SERVICE BULLETIN

POWER PLANT - NACELLE - POWERPLANT - CORE FIRE DETECTOR - REWORK - CATEGORY CODE 7 -
MOD.NAC-71-0145

V2500-NAC-71-0145

ROUTING OF THE CORE FIRE DETECTOR (Before and after)
Fig.1

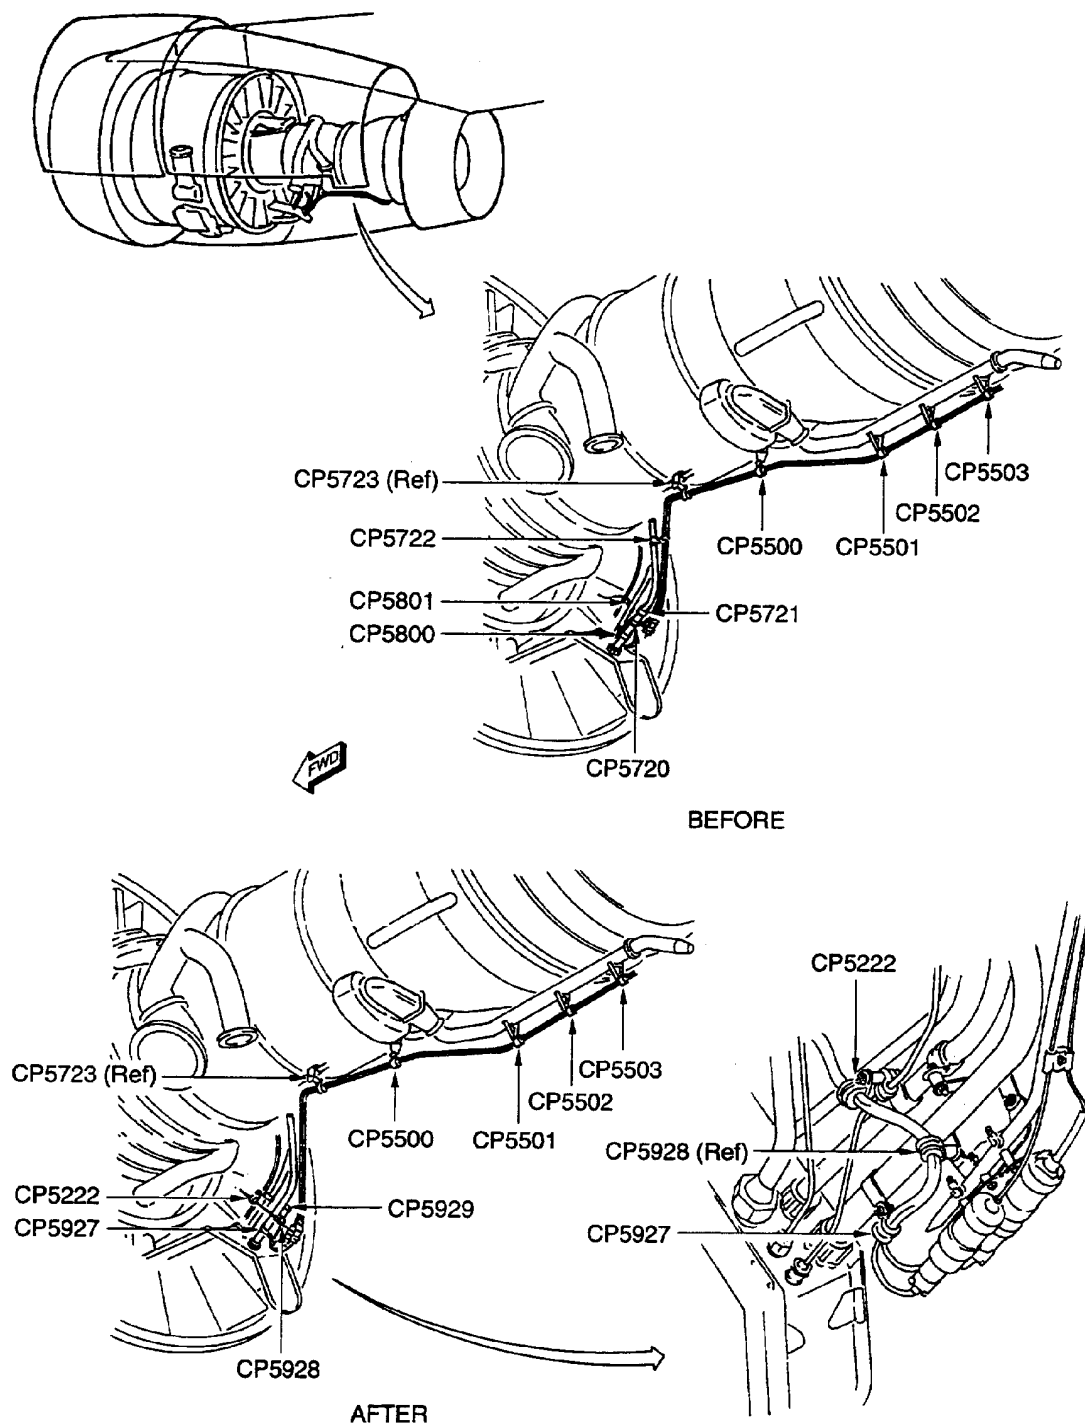
The No.4 bearing scavenge tube is re-routed to avoid interference with the hold open rod of the left cowl (Ref. Service Bulletin V2500-ENG-79-0035). The impact of this re-route is to cause the core fire detector to be moved axially rearwards.

- (a) The core fire detector is installed. The new configuration introduces new clipping points CP5927, CP5928 and CP5929
- (b) A replacement bracket is introduced to support clipping point CP5500.
- (c) A new bracket is introduced to support clipping points CP5928 and CP5929.
- (d) Clipping points CP5720, CP5721, CP5722, CP5800 and CP5801 are made redundant.
- (e) A new clamp is also introduced in support of clipping point CP5222. Refer to Service Bulletin V2500-ENG-79-0035.

- (1) Put the core fire detector with attached support tube onto the engine (Refer to figure 1).

CLIPPING OF CORE FIRE DETECTOR (Before and after)
Fig.2

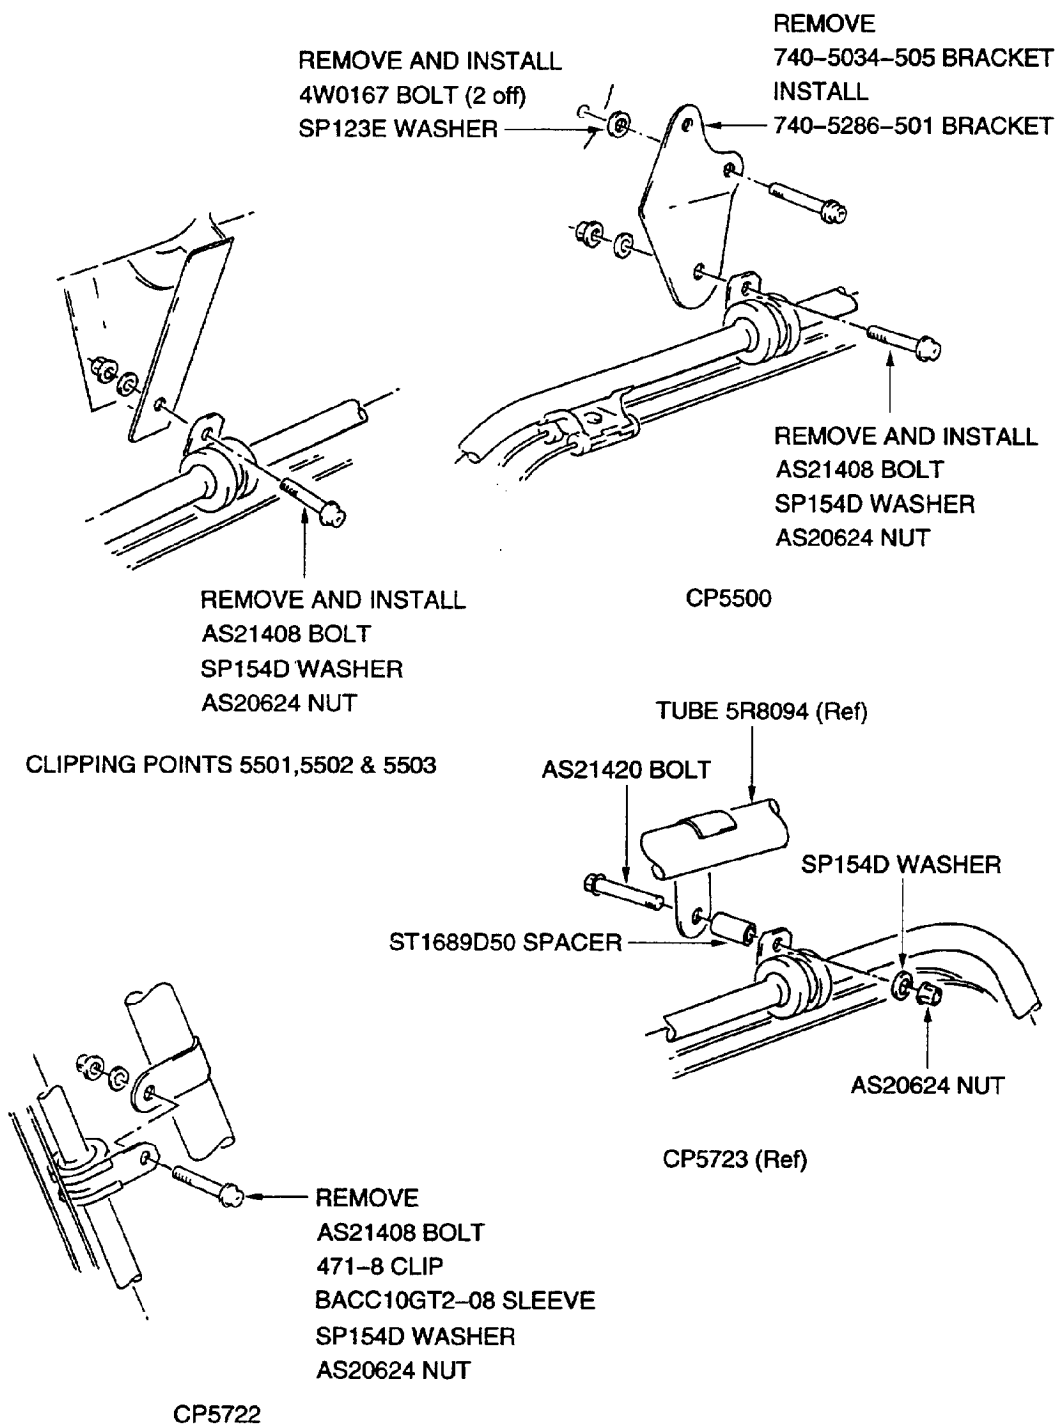
- (1) Remove the two 4W0167 Bolts and one SP123E washer to release the 740-5034-505 bracket from the No. 4 Bearing compartment (Refer to Figures 1 and 2).
- (2) Install the 740-5286-501 bracket as shown , with the two 4W0167 Bolts and SP123E washer (the washer to be put below the bracket). Torque the bolts to between 75 and 85 lb in (8.5 to 9.5 Nm)
- (3) Install the 740-5287-501 bracket to the 740-5032-503 support tube as shown with two AS21418 bolts, two AS20624 nuts and two SP155D washers. Torque the nuts to 40 lb in (4.5 Nm). Refer to Figure 4.

- (4) Attach the Detector Assy at CP5503 to the 740-5035-501 bracket with the AS21408 Bolt, AS20624 Nut and SP155D Washer (Refer to figure 2).
- (5) Attach the Detector Assy at CP5502 to the 740-5035-501 bracket with the AS21408 Bolt, AS20624 Nut and SP155D Washer.

CLIPPING OF CORE FIRE DETECTOR (After)
Fig.4

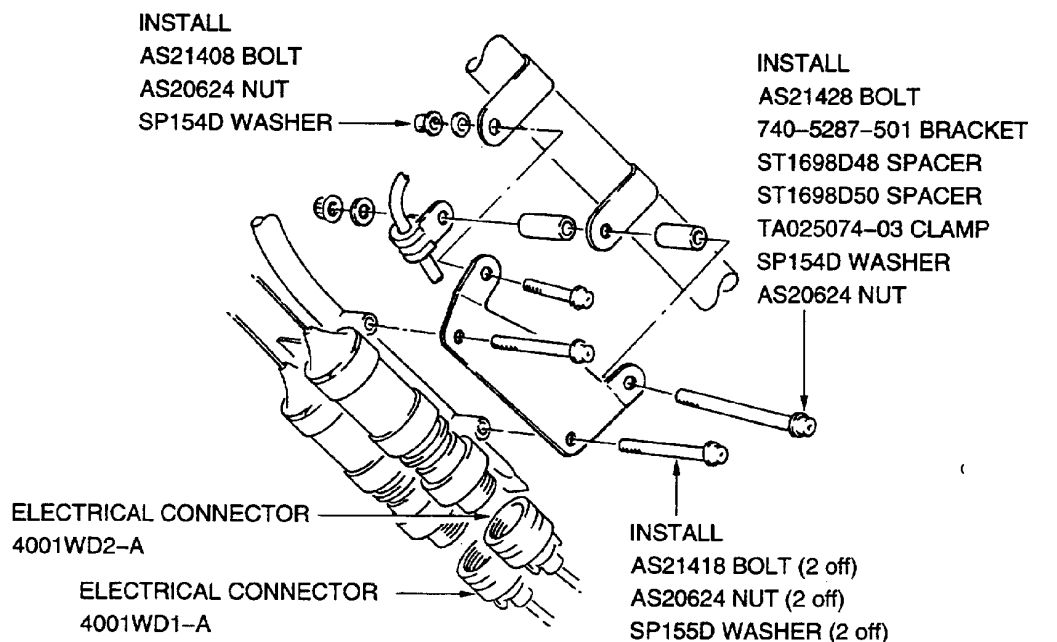
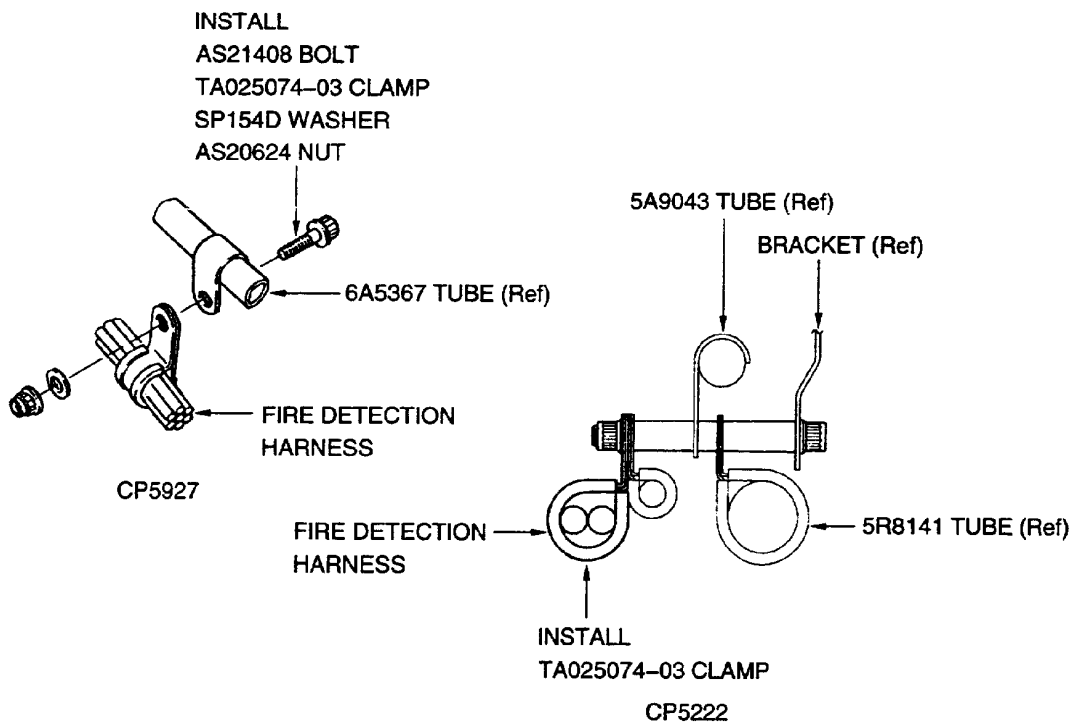
- (2) Attach the Detector Assy to the 6A5367 tube at CP5929 with an AS21408 Bolt, AS20624 Nut, and an SP155D Washer (Refer to Figure 4).
- (3) Attach the Detector Assy to 740-5286-501 bracket at CP5500 with the AS21408 Bolt, AS20624 Nut and SP155D Washer. (Refer to figure 1)

- (6) Attach the Detector Assy at CP5501 to the 740-5035-501 bracket with the AS21408 Bolt, AS20624 Nut and SP155D Washer.
- (7) Assemble clipping point CP5928 to the 740-5287-501 bracket as shown with the TA025074-03 clamp, AS20624 nut, SP155D washer, AS21428 bolt, ST1698D48 spacer and ST1698D50 spacer (Refer to figure 4).
